Reference: Application for Comprehensive Permit- Response to Peer Review Comments
The Pointe At Hills Farm
Shrewsbury, Massachusetts
WDA JN 0927.01 & .02

TITLE: THE POINTE AT HILLS FARM- PHASE I STONEY HILL ROAD GRADING & DRAINAGE EXHIBIT 440 Hartford Turnpike Shrewsbury, MA			
CLIENT: SMART GROWTH DESIGN, LLC 625 South Street, Shrewsbury, MA			
DATE: 10/17/16	FILE NO.: 0927300	SCALE: 1" = 40'	DRAWN BY: WMB
JOB NO.: 0927.07	DWG NO.: 0927311A

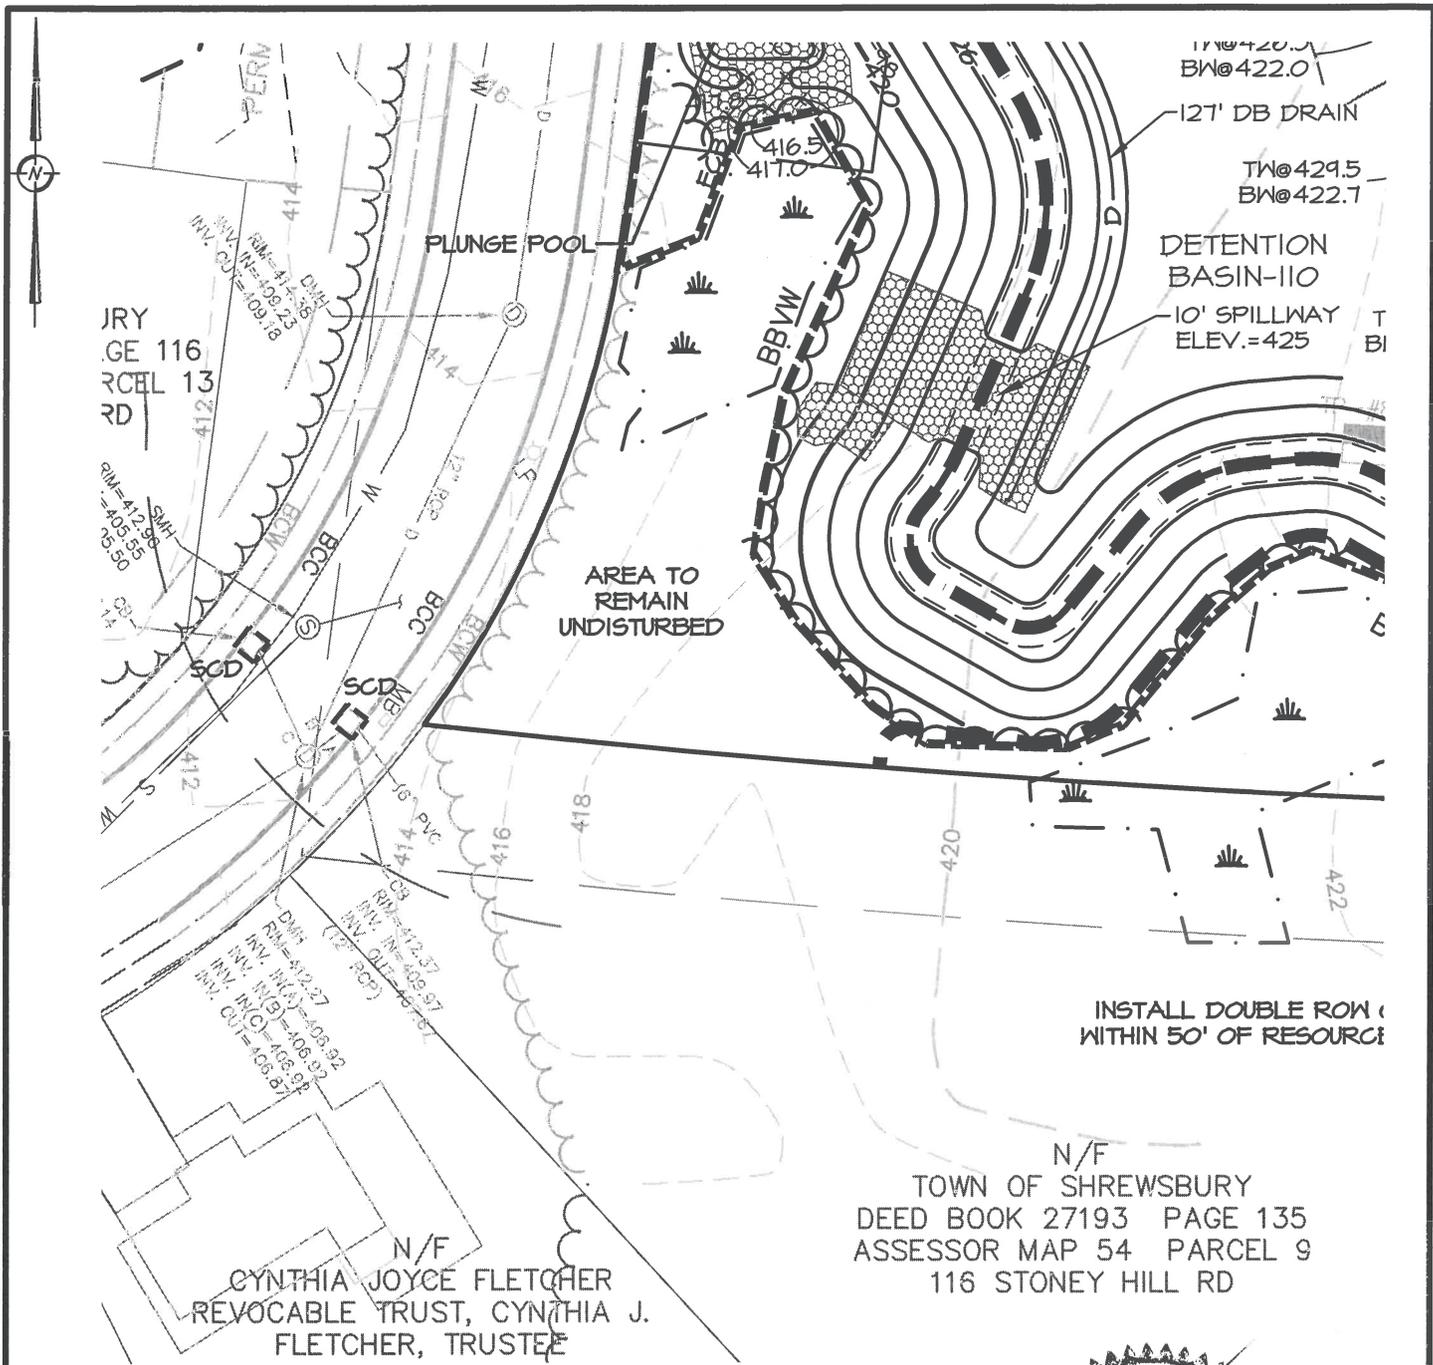
19 *Sheet C1.02 of the plans proposes a new drain pipe to convey stormwater across Stoney Hill Road. During my site visit, I viewed the accumulation of ice on the Stoney Hill Road sidewalk about ten to twenty feet north of the proposed pipe location. This ice was a result of stormwater runoff from the site. In short, the concept of collecting stormwater before it enters the Stoney Hill Road right-of-way doesn't seem unreasonable. However, further consideration of this proposal is warranted. The applicant should elaborate about the ability to obtain permission from the land owner(s) on the southwest side of Stoney Hill Road to install a new pipe and its discharge. Also, the design engineer should provide adequate information to demonstrate that negative impacts downstream of this new discharge point will not occur. Finally, the location of the new drainage pipe's inlet and the drainage system's detailed design will have to be addressed. This level of detail could be done during the preparation of construction plans if the project goes forward.*

The design engineer reported that the applicant has obtained an easement from the downstream property owner to install the drainage improvement. Sheet C1.02 was revised to include additional work at the drainage pipe inlet and outlet. Based upon observations of ice formation and water flow in January 2016 (water flowed from the wetland area in the vicinity of Wetland Flag H), consideration should be given to excavating a shallow depression to direct runoff from this area to the depression around Catch Basin 29. Finally, the engineer has not addressed the potential for negative impacts downstream of the proposed discharge point.

Sheets C1.02 was revised to include a depression to direct runoff to catch basin 29 and Sheet C1.03 was revised to include a new drain manhole (DMH-100). A riprap depression is proposed at the pipe's outlet and there is a receiving water (bordering vegetated wetland) down-gradient of the discharge point. We don't

have an issue with the concept of this proposed system configuration, however we have not received any response pertaining to the potential for negative impacts downstream of the proposed discharge point.

In a recent discussion with the Shrewsbury Town Engineer, we were informed that the creation of an easement in Stony Hill Road to convey stormwater runoff to the record easement at 424 Hartford Turnpike would require a Town Meeting action. With the time expended permitting the project thus far and the potential of not securing a positive vote at Town Meeting, the proposed culvert in Stony Hill Road is no longer a consideration and the current hydrologic flow path into the public road layout will remain. Please refer to the attached stamped Grading & Drainage Exhibit that we request be admitted into the public record. The subject area will remain undisturbed in its natural state. The sketch is intended to supersede the previously proposed relevant improvements in this area shown on Sheet C1.02 of the project site plans. These revised improvements will be incorporated into the construction documents.

THIS EXHIBIT IS INTENDED TO SUPERSEDE THE RELEVANT INFORMATION
SHOWN ON SHEET CI.02 OF THE SITE PLANS DATED 9/20/16.
